# Technical Service Bulletin

## 40 Rattling or knocking noise from front end when driving over bumps

40 18 87 2035854/5 November 21, 2018. Supersedes Technical Service Bulletin Group 40 number 14-43 dated October 9, 2014 for reasons listed below.

**Figure 1.** Lower guide link (1).

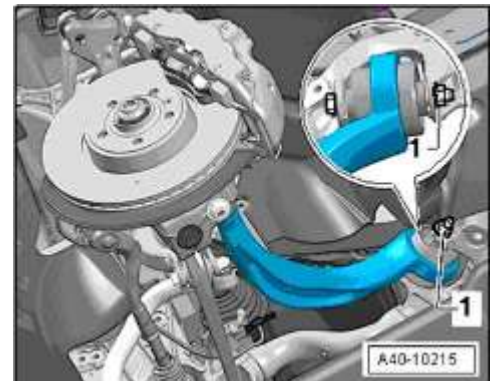
1. Before proceeding, confirm that the noise is coming from the hydraulic guide links and not from other suspension components on the vehicle (such as worn or damaged bushings).  
Additionally, ensure that the vehicle is equipped with 75mm bushings. Review the repair history of the vehicle and ETKA to determine which bushings are present.
2. Check the size of the ball joints. In 2010, ball joint sizes were changed from M12 to M14.

- **If the vehicle was produced with M14 ball joints:**  
Replace both left and right lower guide links (Figure 1) according to the instructions in Elsa at Repair Manual, *Chassis >> Suspension, Wheel, Steering >> Front Suspension >> Removal and Installation >> Guide Link*.

- **If the vehicle was produced with M12 ball joints:**  
Replacement of the complete guide link is not possible. Only the bushings should be replaced. Remove the guide links and replace the left and right bushings.
